#### **ACER Decision on Core ID CCM: Annex I**

# The second amendment to the intraday capacity calculation methodology of the Core capacity calculation region

in accordance with Articles Article 20ff. of the Commission Regulation (EU) 2015/1222 of 24#24 July 2015 establishing a guideline on capacity allocation and congestion managements

09-08-2022

Equation 14a

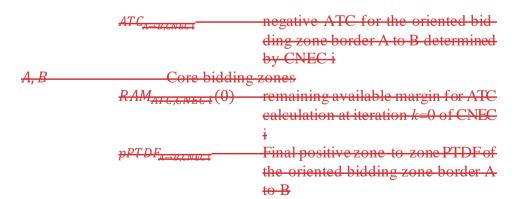
$$\begin{split} &ATC_{A \to B, CNEC \ i} \\ &= \frac{pPTDF_{A \to B, CNEC \ i}}{\sum_{(A,B) \in \ Core \ contract \ paths \ with \ positive \ z2zPTDFs} PTDF_{A \to B}^2} \ RAM_{ATC \ ,CNEC \ i}(0) \end{split}$$
